# GRADING AND DRAINAGE PLAN

## FOR PUYALLUP CORPORATE PARK

A PORTION OF THE NE¼ OF THE SW¼ OF SEC. 26, TWP. 20 NORTH, RGE. 4 EAST, W.M.  
CITY OF PUYALLUP, PIERCE COUNTY, WASHINGTON

Job Number: 20705  
Sheet: C4 of 23

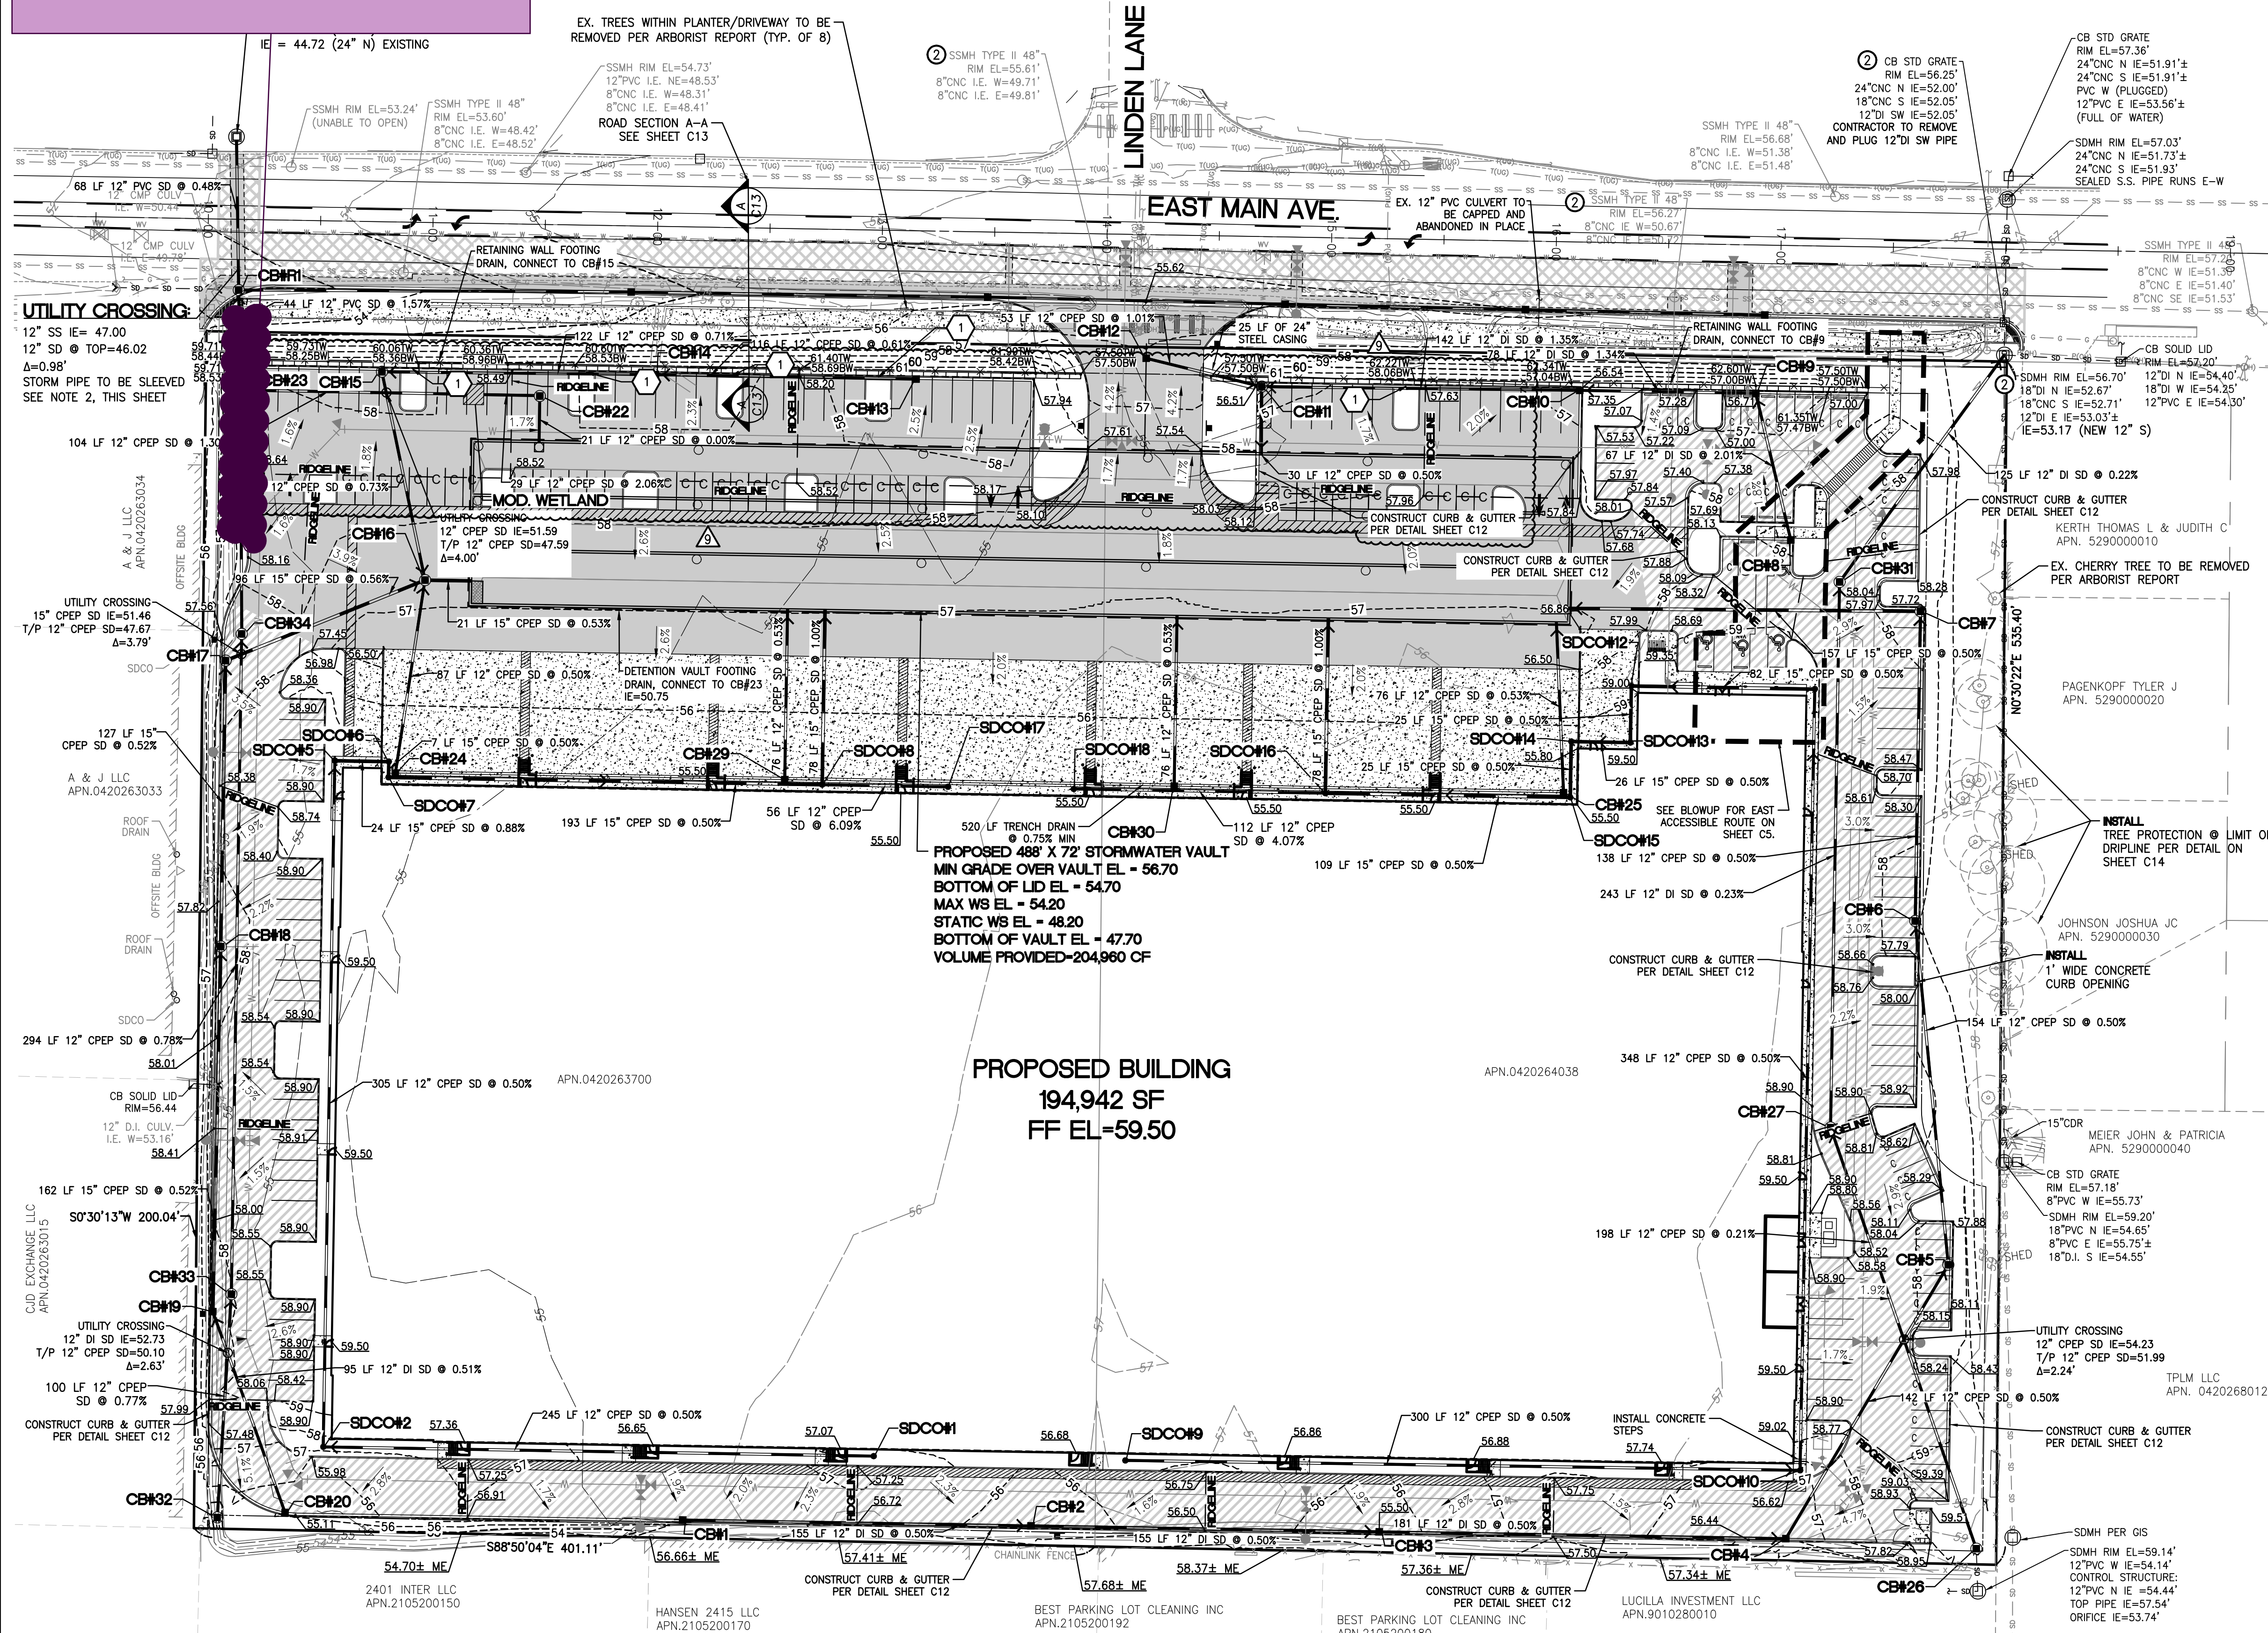
Pedestrian connection from the sidewalk to the NW building entry required per PMC 20.35.025(16). Walkway is shown on landscape plan and site plan, but not on the civil drawings; please correct. Provide elevations of the retaining wall/fence in this area and ensure there are no conflicts with the walkway. Walkway must meet the following standards per code: (a) All walkways shall be a minimum of five feet wide with no encroachments permitted; (b) All walkways shall be handicapped accessible and comply with the Washington State Barrier Free Design Standards; (c) All walkways shall be delineated by painted markings, distinctive pavement, or by being raised a minimum of six inches above the parking lot pavement; (d) Walkways within employee/customer parking lots shall be located along major access corridors, and located away from truck parking and loading/unloading areas whenever possible; and (e) Walkways within employee/customer parking lots shall be integrated into interior landscape areas, whenever possible, to separate pedestrian access and vehicular travel routes (Civil Plan, Sheet C4).
